Access Compliance Report

Public Rights-of-Way

(Curb Ramps)

Intersection ID: 52613	Main Street: GRAHAM RIDGE DR	Cross Street: HERITAGE POND DR	Location: NW
ADA ID: 378B0499AD0E	Ramp Type: BlendTrans1	Initial Pass/Fail: Pass	Overall Compliance: No
Severity Score: 0			
Codes/Mitigation Info/Possible Solution		Field Measurements/Component Compliance

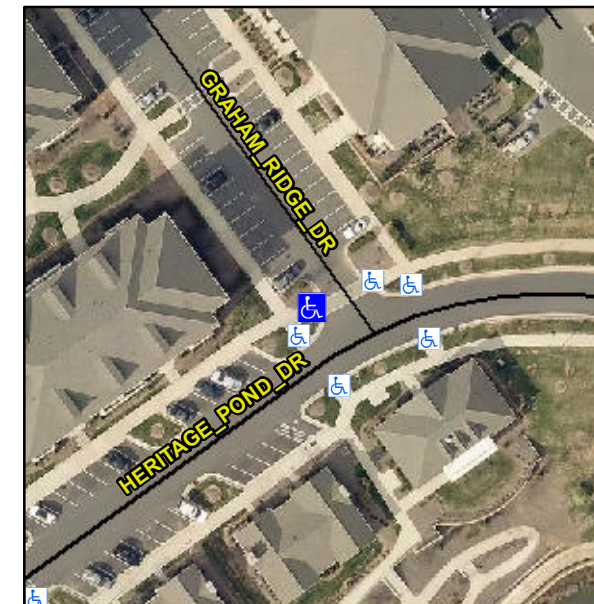
PROW/ADA:

Not Found, R305.2

Compliance	Description	Data	Compliance	Description	Data
N/A	Ramp Length (in)	82.0	Yes	BlendTrans Slope (%)	1.2
Yes	Ramp Width (in)	82.0	Yes	BlendTrans XSlope (%)	1.0
Yes	Flare Type L	Curbed_NoWalkSurface	Yes	Flare Type R	Curbed_NoWalkSurface
N/A	Flare Slope LT (%)	N/A	N/A	Flare Slope RT (%)	N/A
N/A	Flare Traversable LT?	No	N/A	Flare Traversable RT?	No
Yes	Landing Length (in)	58.0	Yes	DWS Provided?	Yes
Yes	Landing Width (in)	84.0	Yes	DWS Contrast?	Yes
Yes	Landing Slope (%)	0.4	Yes	DWS Length (in)	24.0
Yes	Landing X Slope (%)	0.0	Yes	DWS Full Width?	Yes
N/A	Landing Curb? (Y/N)	No	No	DWS Offset (in)	9.0
N/A	Shared Landing?	No			
Yes	Gutter Ponding?	No	Yes	Gutter Slope (%)	1.4
Yes	Gutter Lip Ht (in)	0.0	Yes	Gutter X Slope (%)	0.7
N/A	Painted X Walk1?	Yes	N/A	Painted X Walk2?	N/A
	X Walk 1 Direction	To NE		X Walk 2 Direction	N/A
	X Walk 1 Width (in)	71.0		X Walk 2 Width (in)	N/A
	X Walk 1 Slope (%)	0.9		X Walk 2 Slope (%)	N/A

X Walk 1 X Slope (%)	1.4		X Walk 2 X Slope (%)	N/A
Yes	Ramp inside XWalk1?	Yes	N/A	Ramp inside XWalk2?	N/A
	Road Slope (%)	1.4		Clear Space?	Yes
	Road X Slope (%)	0.9	N/A	Clear Space to XWalk (in)	N/A
Yes	Any Obstructions?	No	Yes	Storm Grate/Utility Hazard?	No
	Obstruction Type			Storm Grate/Utility Type	
		N/A			N/A
			Yes	Surface Condition? (G/P)	Good
			No	Curb Slope (%)	14.1

Possible Solutions:

Remove & Replace Curb Ramp With Two New Directional Ramps or Equivalent.
